IR2020-3 Avoidance and mitigation measures for project operation and marine shipping incidental to the project

Vancouver Fraser Port Authority
Roberts Bank Terminal 2 | Information Request 2020-3

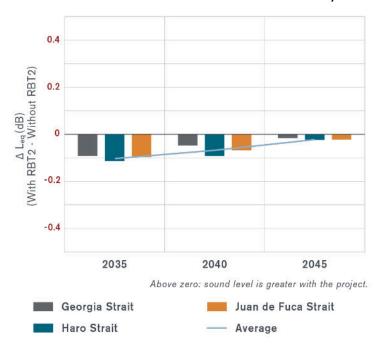
The estimates of sound exposure levels provided in **Appendix IR2020-3-E** confirm that, with or without the project, sound exposure levels would vary by only minor amounts depending on location and year and are relatively similar over the forecasted period (i.e., 2035, 2040, and 2045). With all three model locations combined, the annual time-averaged sound level (Leq-1yr) for the most-realistic vessel scenario is anticipated to be the same with or without RBT2 (i.e., differences are so small as to be considered not measurable; **Figure IR2020-3-3**), even though container vessels calling at RBT2 are projected to be larger on average and the source levels of these larger vessels were conservatively estimated to be higher (**Appendix IR2020-3-E**). These results are consistent with what was presented at the public hearing, where it was concluded that there would be no appreciable increase in sound exposure levels in the marine shipping area with the project based on the 2018 projection (Mercator International 2018).

As illustrated in **Figure IR2020-3-3**, L<sub>eq-1yr</sub> ranged from less than 0.1 dB lower with RBT2 in 2035 and 2040 to less than 0.03 dB lower in 2045 with the project (**Appendix IR2020-3-E**). Even though not considered a measurable difference, L<sub>eq-1yr</sub> is predicted to be slightly lower with RBT2 in 2035 as Neo-Panamax container vessels are predicted to replace the Large Post Panamax container vessels that were predicted to call at the Port of Vancouver without the project. This is because measured noise emissions from the Large Post Panamax vessels class are slightly higher than the larger Neo-Panamax (**Appendix IR2020-3-E**; MacGillivray et al. 2020).

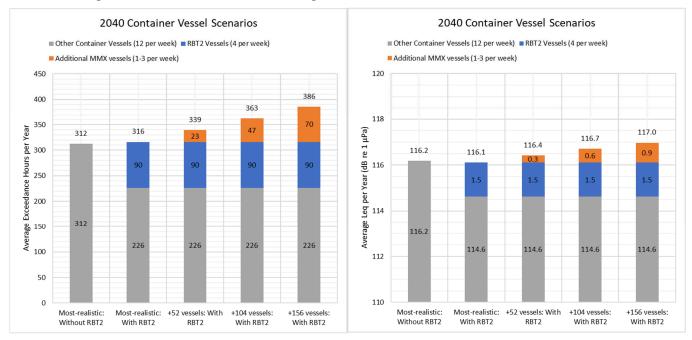
Under the less likely high-case vessel scenarios, the annual time-averaged sound level ( $L_{\text{eq-1yr}}$ ) is predicted to increase by 0.3 dB to 0.9 dB with an additional one to three calls per week (or 52 to 156 container vessels annually) transiting the marine shipping area in 2040 compared to the most-realistic scenario of 832 container vessel calls annually with or without RBT2 (**Figure IR2020-3-5**). For exceedance hours, it is estimated that additional container vessels could increase exceedance hours by 23 hours to 70 hours (7% to 22%) under the high-case vessel scenarios of an additional 1 to 3 Mega-Max container vessels transiting the marine shipping area per week (**Figure IR2020-3-5**). As exceedance hours increase with vessel size, the conservative assumption that additional vessels would be the largest vessel class (i.e., Mega-Max container vessels) influences the increase in exceedance hours under the high-case vessel scenarios.

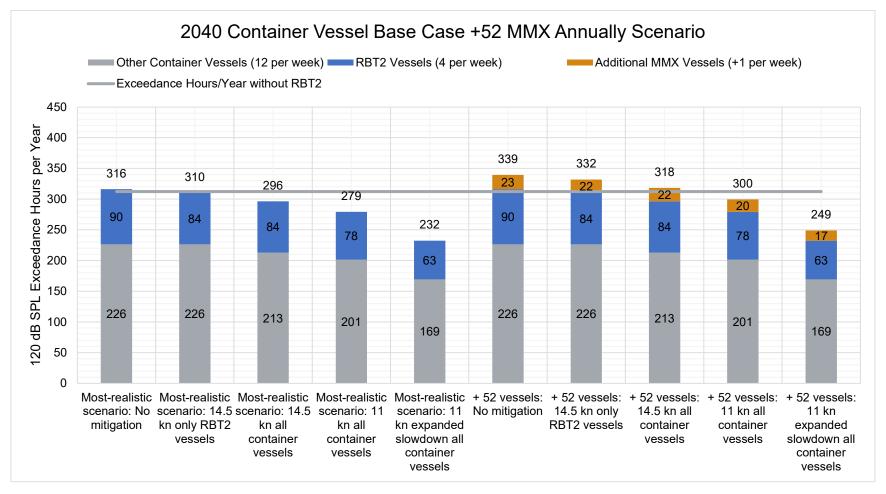
- 52 additional Mega-Max vessels annually could be mitigated by further reducing transit speed for six months from 14.5 knots to 11 knots (**Figure IR2020-3-7**).
- 104 additional Mega-Max vessels annually could be mitigated by further reducing the transit speed for six months to 11 knots combined with expanding the slowdown area to include Juan de Fuca Strait and the Strait of Georgia (Figure IR2020-3-8).

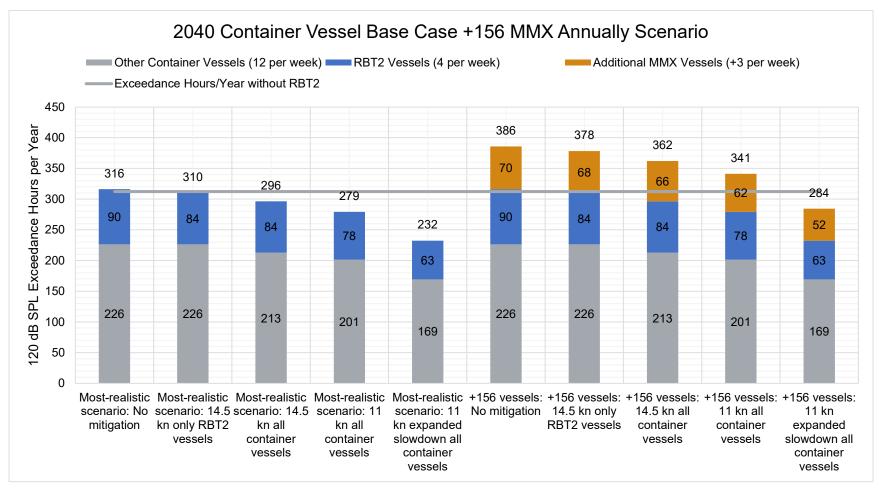
156 additional Mega-Max vessels annually could be mitigated by further reducing the transit speed for six months to 11 knots combined with expanding the slowdown area to include Juan de Fuca Strait and the Strait of Georgia (Figure IR2020-3-9).
